UNITED STATES PATENT AND TRADEMARK OFFICE

| APPLICATION NO. | FILING DATE | FIRST NAMED INVENTOR | ATTORNEY DOCKET NO. | CONFIRMATION NO. |
|-----------------|-------------|----------------------|---------------------|------------------|
| 10/632,545 | 08/01/2003 | Michael F. Brletich | 12539 | 2681 |

Office Action Summary

DETAILED ACTION

FIG. 35

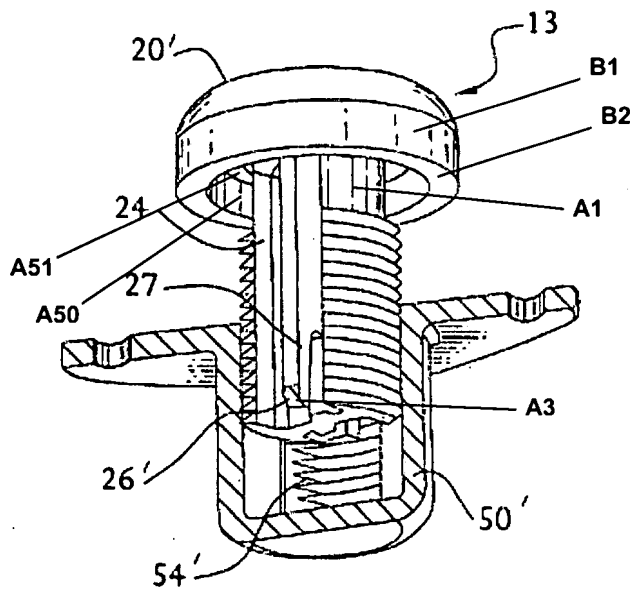
Regarding claim 9, Antonucci et al. disclose, in Fig. 35, a device comprising a fastener plug **13** including an end cap **20'** and at least one disc **28** spaced apart from the end cap **20'**. The fastener plug **13** defines a flexible extension member **27** extending outwardly from the end cap **20'** and across the at least one disc **28**. The flexible extension member **27** has a fixed end connected to the end cap **20'** and a free end opposite the fixed end. The free end includes an aperture engaging-member **26'**. The end cap **20'** defines a peripheral edge. However, Antonucci et al., fails to disclose a flat truncated surface along the peripheral edge. Applicants are reminded that changing the shape of the end cap to include a flat truncated surface is an obvious modification since changing the shape in Antonucci et al. is not critical to practicing the invention and one skilled in the art at the time the invention was made would have changed the configuration to a polygonal head or a non-round configuration to align the aperture engaging-member along the flat truncated member to locate the orientation of the aperture engaging-member as compared to the rib (unreferenced) on the end cap.

Regarding claim 1, the fastener plug **13** includes a plug portion **20'** and a fastener portion **24**. The plug portion **20'** defines the end cap **20'** and the at least one disc **28**. The fastener portion **24** defines the flexible extension member **27**. The end cap **20'** includes at least one retaining wall **A50** (see marked-up attachment) extending outwardly from an inner surface **A51** of the end cap **20'**. The projecting member **26'** is a projecting member.

Regarding claims 3 and 11, a rib **A1** (see marked-up attachment) connects the disc **28** to the end cap **20'**.

Regarding claims 4 and 12, the disc **28** is a plurality of discs **28** spaced apart from the end cap **20'**.

Regarding claims 5 and 13, the extension member **27** extends upwardly from the end cap **20'**.

Regarding claims 6 and 14, the extension member **27** extends across the discs **28**.

Regarding claim 7, the discs **28** define a flat surface edge **A2**.

Regarding claim 8, the projection member **26'** defines an inclined surface **A3**.
